Water Licence Inspection Report

Authorization	Representative
WhiteCliff Minerals	**Eric Sondergaard**
Authorization No. / Expiry	**Representative's Title**
2BE-RCE2532	
Inspection Date	**Inspector**
July 02, 2026	**Isaiah James Bolt**
Other Authorization/s	
N2024C0029	
Activities Inspected	
☐**Municipal** ☒ **Camp, Commercial** ☐ **Drilling** ☐ **Mining** ☐ **Construction** ☐ **Reclamation** ☒ **Fuel Storage** ☐ **Roads/Hauling** ☐ **Winter Hauling** ☐ **Camp, Private** ☐ **Other** Click or tap here to enter text.

On July 02, 2026 Resource Management Officer Isaiah James Bolt (Inspector) for Crown Indigenous Relations and Northern Affairs Canada (CIRNAC), conducted an inspection of 2BE-RCE2532 (License) issued to Whitecliff minerals (Proponent) to ensure compliance against their license.

Photo #	9	Coordinates:

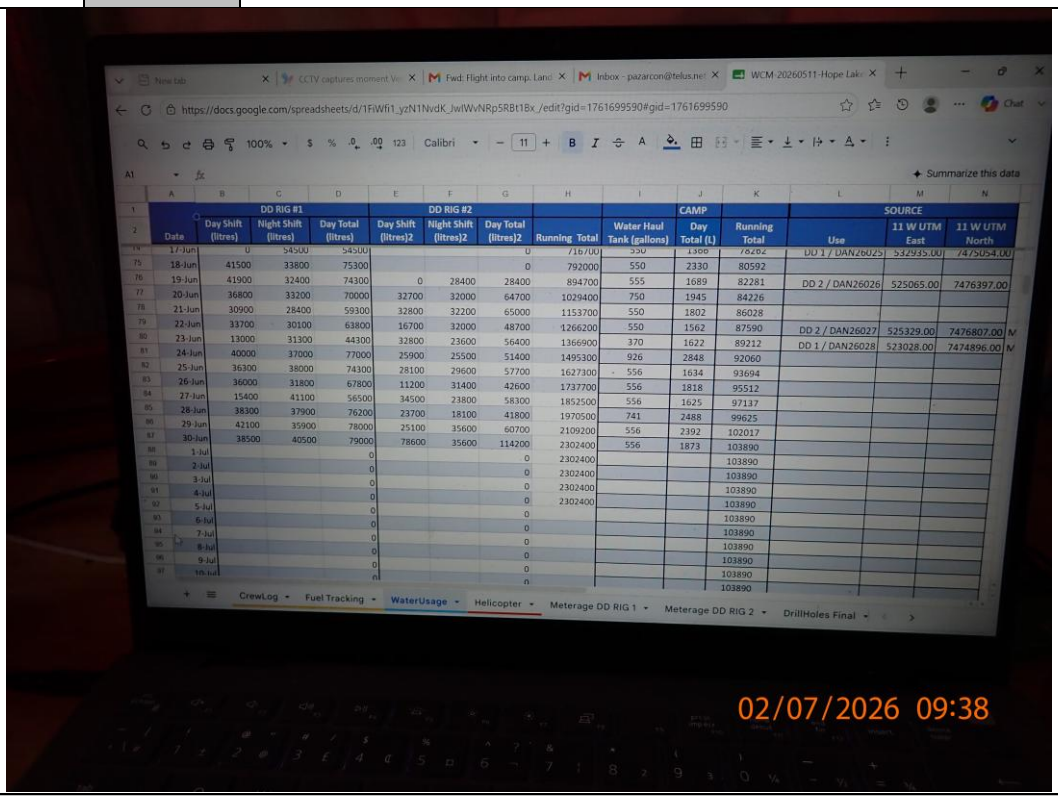
8. Grey water discharge location was observed. No concerns noted (Photo #8).
9. A photo of the water usage log was taken (Photo #9). Based on the water logs and the total allowable withdrawal limits found in the license the proponent is well within their daily limits.
